TO: Planning Commission acting as Historic Landmarks Commission (HLC)
FROM: Jennifer Dimsho, AICP, Associate Planner
RE: Historic Resource Review HRR.1.22 (251 St. Helens Street – John Gumm School)
Plan Revisions
DATE: February 6, 2024

HISTORIC RESOURCE REVIEW: REVISION REQUEST
JOHN GUMM BUILDING #2141

RE: Historic Resource Review, HRR.1.22 (dated 12.15.22)

**JOHN GUMM BUILDING
CIVIC OFFICES**
251 St. Helens Street
St. Helens, Oregon 97051

2A. View from SW during construction showing full facade

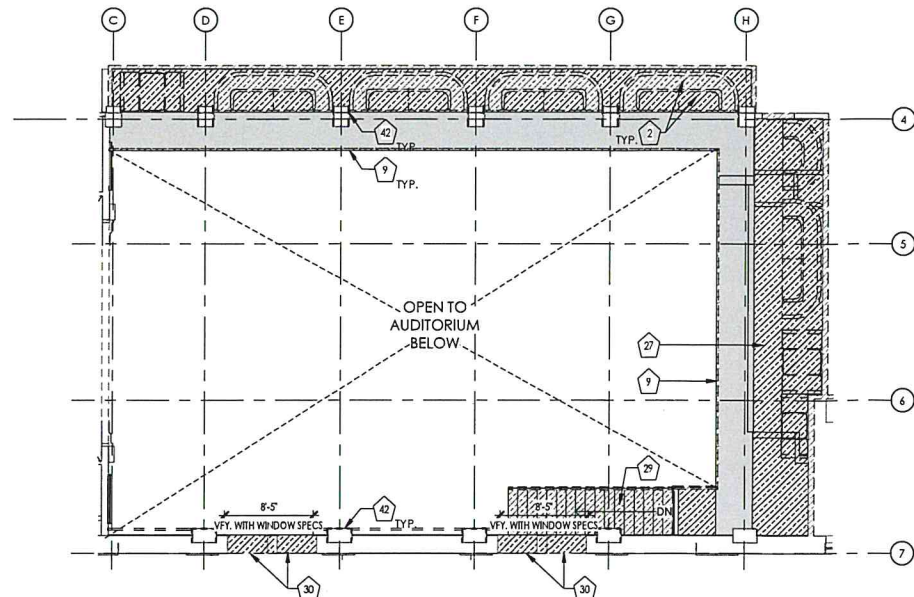
Also included are photos of the stair prior to the start of construction and a current photo of the condition during construction. In the current construction photos, the project team plans to reinstall the roof per the original design, and to close the opening to the former stair from the landing with a new guardrail (continuing the previously approved approach), as noted in the permitted construction documents.

DA1.11

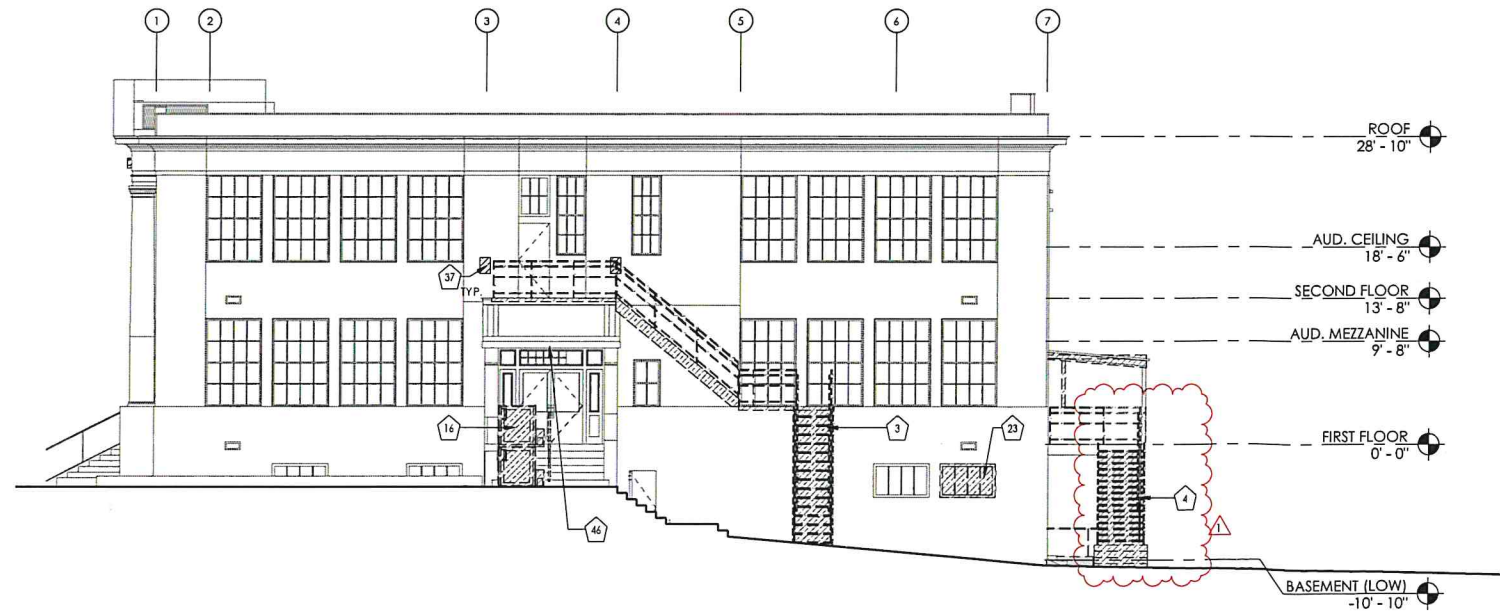
During construction, unexpectedly poor soils were discovered at the rear of the building. Remediation of this issue required removal of the exterior stair at the back of the building. As there are no longer egress or functional uses for this stair, the project team proposes to permanently remove this element from the building to avoid the building security issues and cost associated with its reconstruction. The stair is not a character-defining feature of the building and its removal is in conformance with SHMC 17.36.040 Criteria for Alteration. Removal of the stair will also improve views to and from the basement windows on the rear façade.

To illustrate this proposed change, proposed revisions to the permitted construction documents are attached to this memo. Proposed changes are "clouded" for clarity.
